UNITED STATES PATENT AND TRADEMARK OFFICE

APPLICATION NO.	FILING DATE	FIRST NAMED INVENTOR	ATTORNEY DOCKET NO.	CONFIRMATION NO.
09/809,052	03/16/2001	Shigeru Hayakawa	000400-817	4764

Office Action Summary

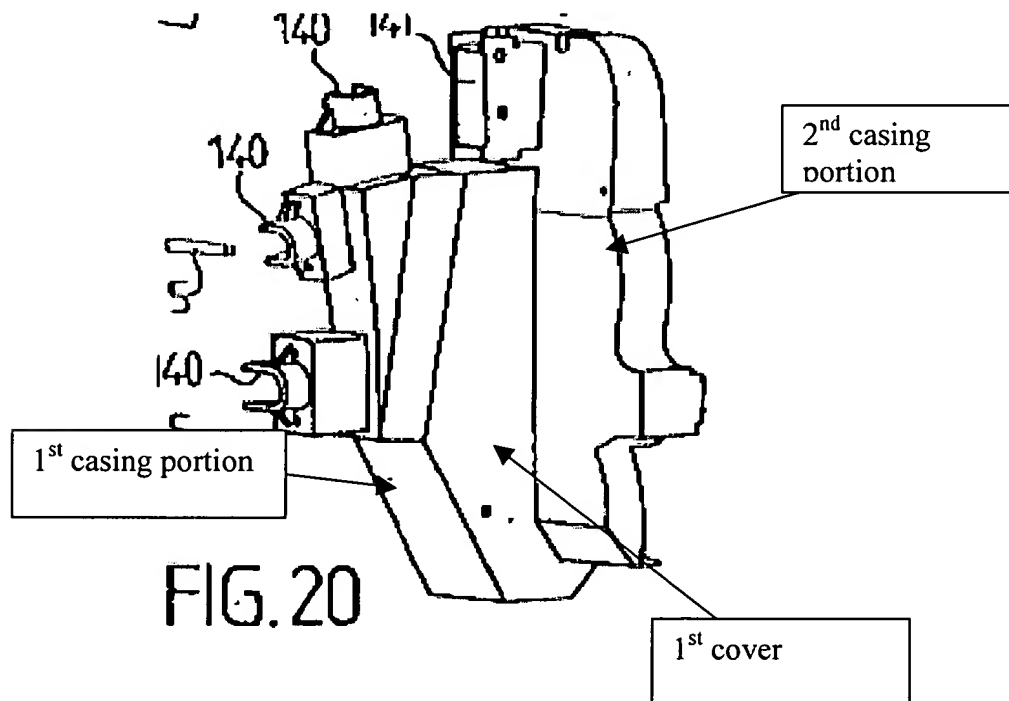
Claim 20 is rejected under 35 U.S.C. 103(a) as being unpatentable over DeBlock US6497436 in view of case law.

As to claim 20, DeBlock discloses, a door lock system for a vehicle comprising: a housing (see Figure 20 below) comprised of a main body, a first cover and a second cover 2, the main body comprising a first casing portion and a second casing portion, with a first space between the first cover and the first casing portion, the second casing portion having an open end closed by the second cover with a second space between the second cover and the second casing portion, the first and second casing portions being connected to each other and being oriented relative to one another such that the first casing portion and the open end of the second casing portion face in directions perpendicular to one another; a latch mechanism 14,16 adapted to latch a vehicle door to a vehicle body and supported by the second cover (14 and 16 are supported by axles mounted to holes in the second cover 2); and a link mechanism including an electric driving source 66 (see Figure 11) and a plurality of lever members 62,68 for selectively locking and unlocking the latch mechanism (col.10, ln.25-50), the link mechanism being accommodated

in the housing with each of the lever members being disposed within at least one the first space and the second space, the lever members including an open link 63,64 coupled to the electric driving source to selectively lock and unlock engagement of the latch mechanism, and both the electric driving source and the open link being disposed within the first space. The difference between the claim and DeBlock is the claim recites, the first casing portion having an open end closed by the first cover. DeBlock discloses the claimed limitations except for the first casing portion having an open end closed by the first cover. It would have been obvious to one of ordinary skill in the art at the time the invention was made to make the first cover and the first casing portion separate, since it has been held that constructing a formerly integral structure in various elements involves only routine skill in the art. *Nerwin v. Erlichman*, 168 USPQ 177, 179.
